## S E R V I C E N O T E

**OmniBER 37718 / 37719 Comms Performance Analyzer****Build Code Status 3:30 and below**

**Situation**

The following modification is recommended to eliminate potential overheating and premature failure of DS<sub>n</sub> DS1 Drop (Demux) Port driver.

Figure 1. Location of Components.

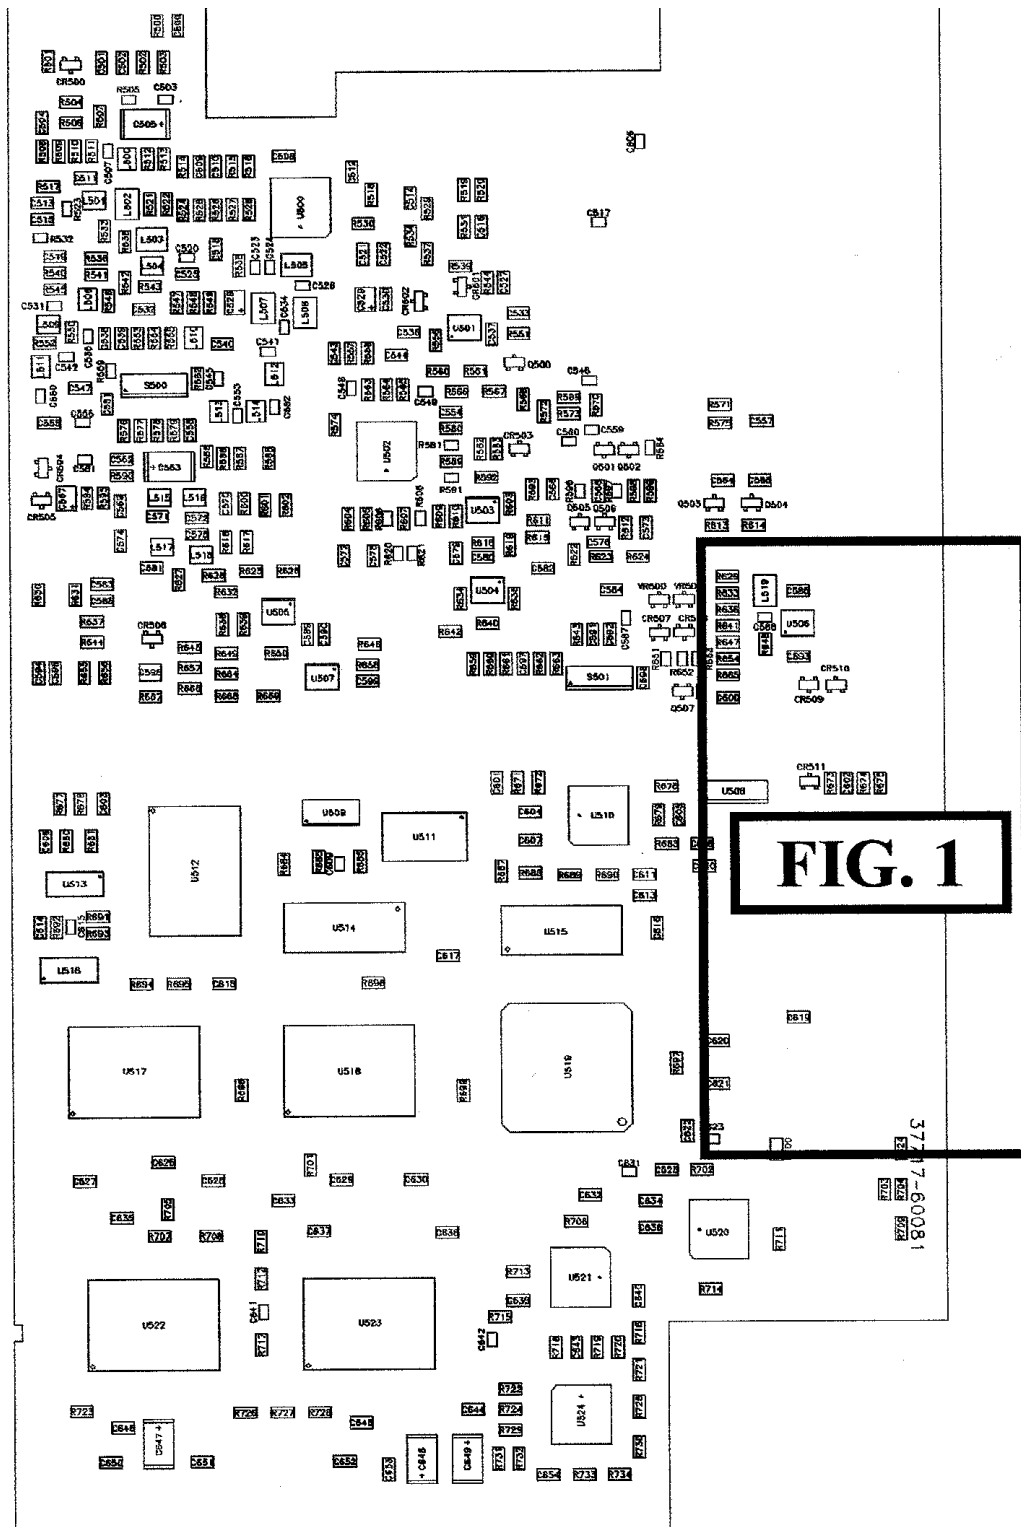
If failure of the DS1 Drop (Demux) Port is already evident, the U506 will also need to be replaced, before implementing this modification.

2. Note: Only perform this step if DS<sub>n</sub> Drop Port is defective. Remove/replace U505 (PN 1820-8942) taking note of orientation.
3. Solder a 10k ohm resistor Ra (0699-1391) to rh pin of TP8.
4. Solder a 10k ohm resistor Rb (0699-1391) to rh pin of TP8.
5. Add a wire link from vacant end of Ra to U506 pin 1 using insulated wire (see Figures 1 and 2).
6. Add a wire link from vacant end of Rb to U506 pin 7 using insulated wire (see Figures 1 and 2).
